REV	DATE	DESCRIPTION	BY	CHK
01	06.09.23	STAGE 1 SUBMISSION	01	01
© This drawing is the property of Kennedy Redford Limited and all information can only be reproduced with their prior permission.				
 Kennedy Redford MANAGING VISION				
CLIENT				
 MORGAN SINDALL CONSTRUCTION				
PROJECT NAME				
STAR RADCLIFFE ACADEMY, BURY				
DRAWING TITLE				
PROPOSED EXTERNAL LIGHTING LAYOUT				
DATE	SCALE	SHEET SIZE	REV	
07.09.23	1:500	A0	P01	
DRAWING STATUS				
S4 - LAP AUTHORISATION				
DRAWING NUMBER				
FS1013 - KRD - EX - XX - D - E - 9003

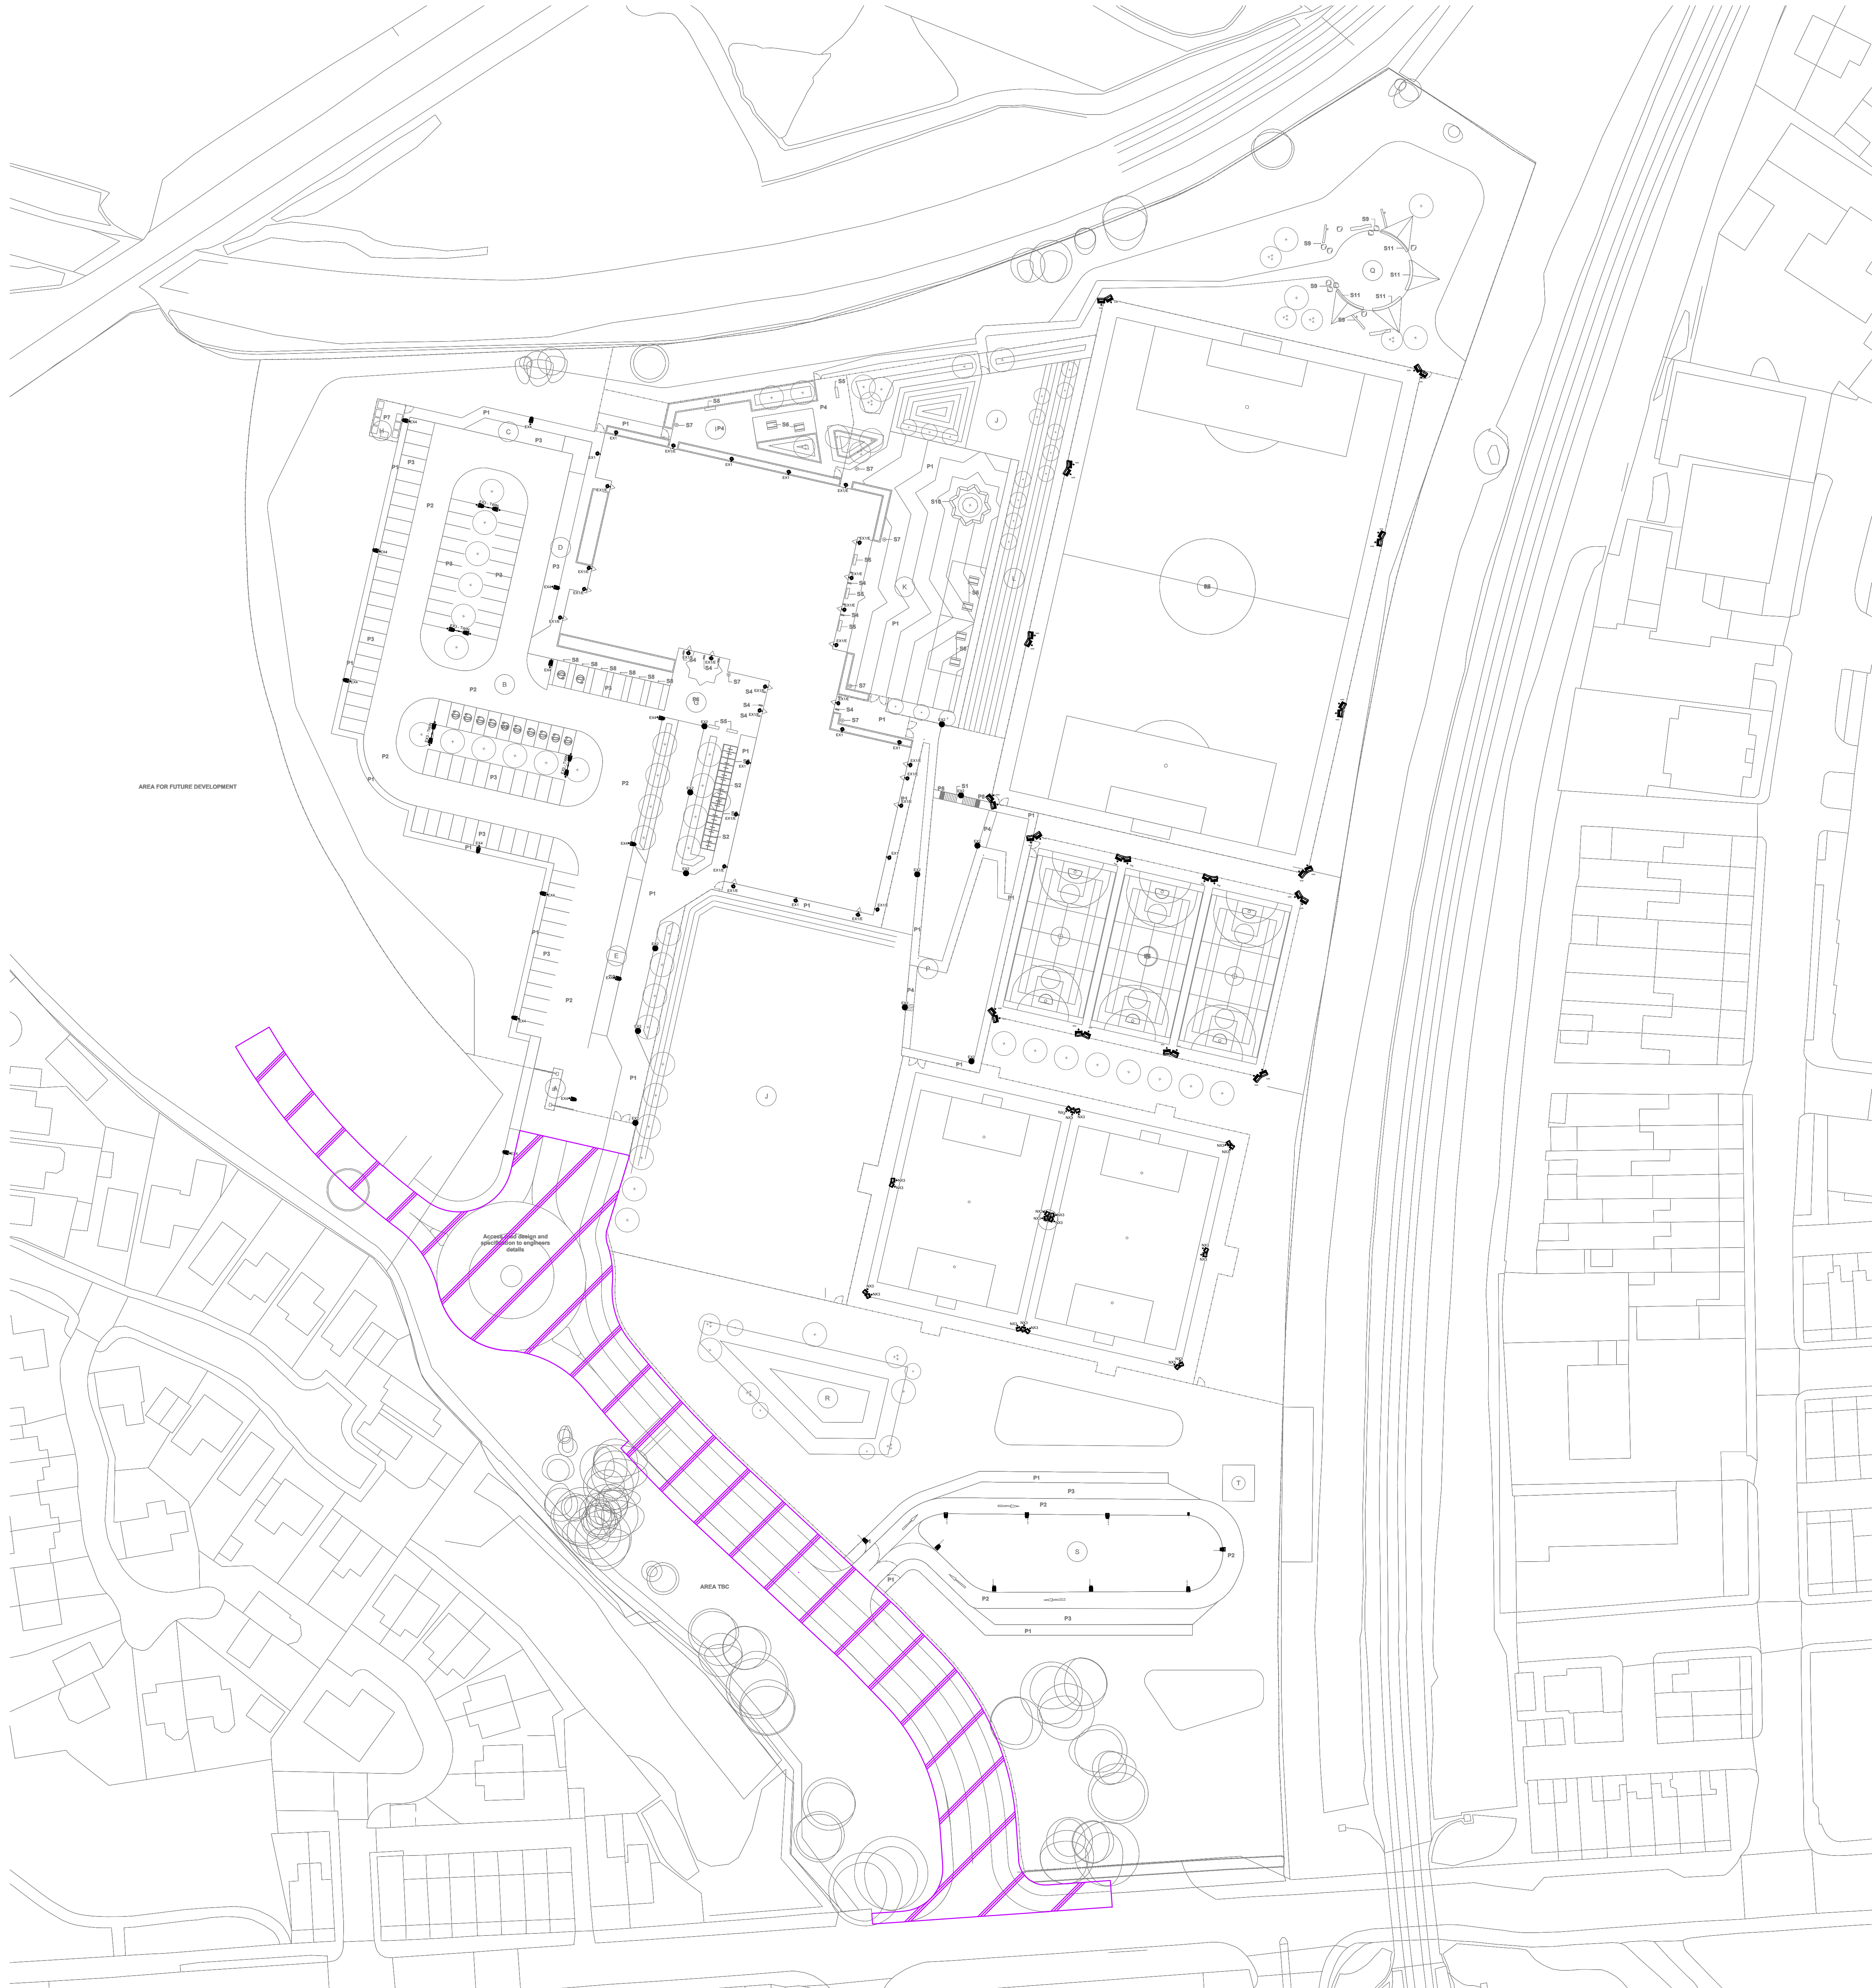
10. THE LIGHTING DESIGN FOR THE ACCESS ROAD IS TO BE BY THE COUNCIL/LOCAL HIGHWAY AUTHORITY. COULD WE MAKE THE NOTE ON THE PLAN REGARDING THE ACCESS ROAD LARGER AND MORE SPECIFIC TO CONFIRM THE ACCESS ROAD'S LIGHTING DESIGN WILL BE TO THE LOCAL HIGHWAY AUTHORITY'S SPECIFICATIONS AND TO ADOPTABLE STANDARDS.
